NON-MATERIAL AMENDMENT APPLICATION :- 14 Sunnydene Avenue, HA4 6AF

This application seeks consent for non-material amendments to the planning permission 26362/APP/2025/692. These proposed changes are as follows:

SIDE ELEVATIONS: AS APPROVED AND PROPOSED

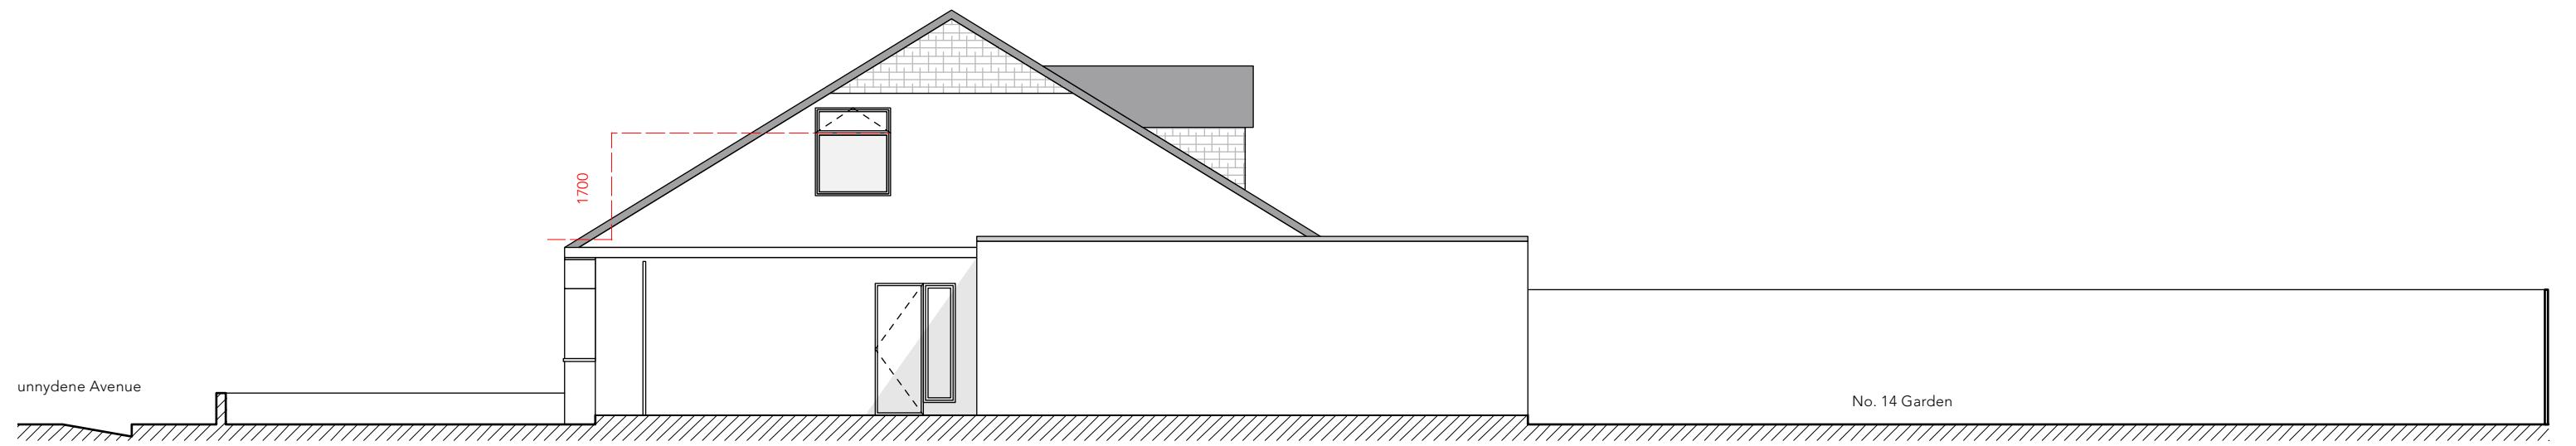
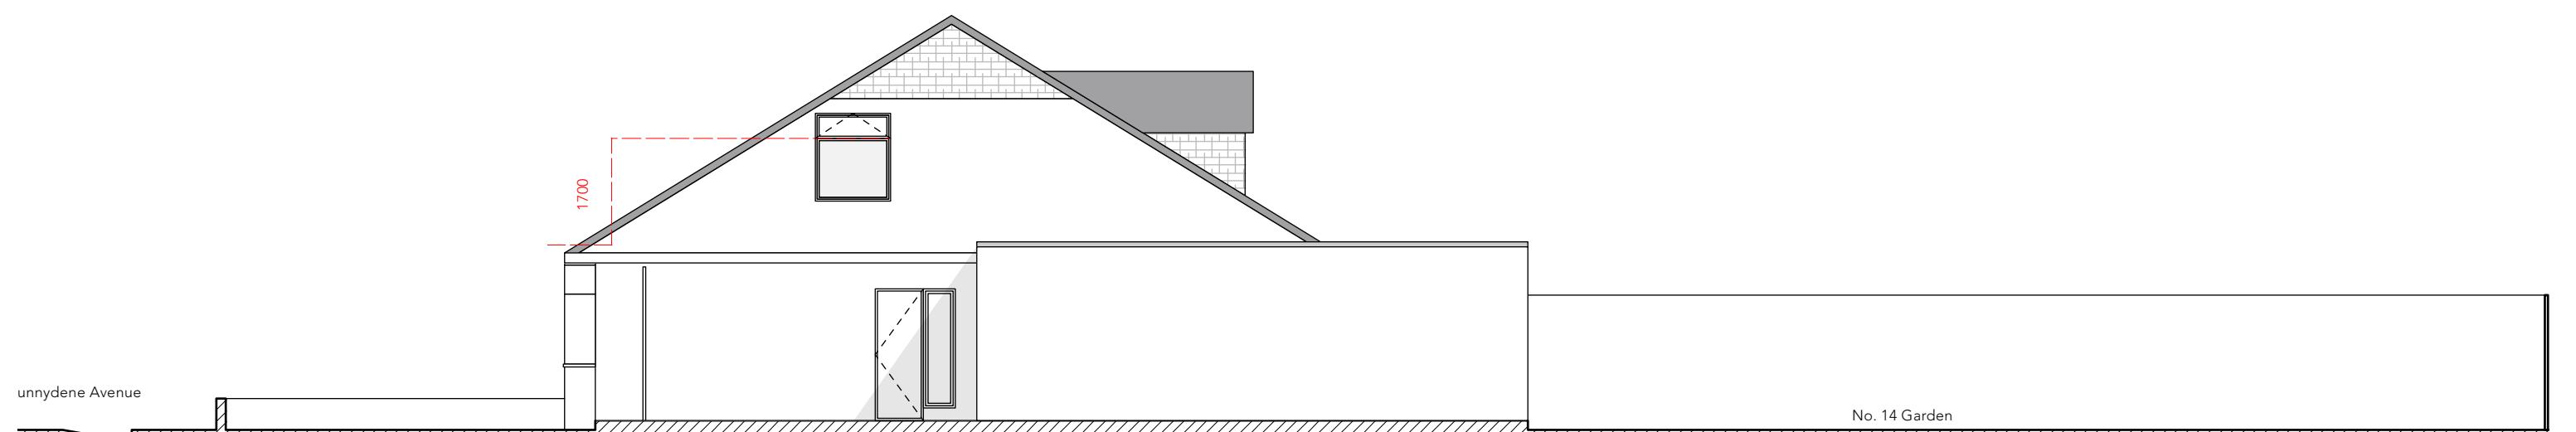
- 1: bricked up front entrance
- 2: Proposed rooflight
- 3: Proposed timber framed door
- 4: Amended location for approved rooflights
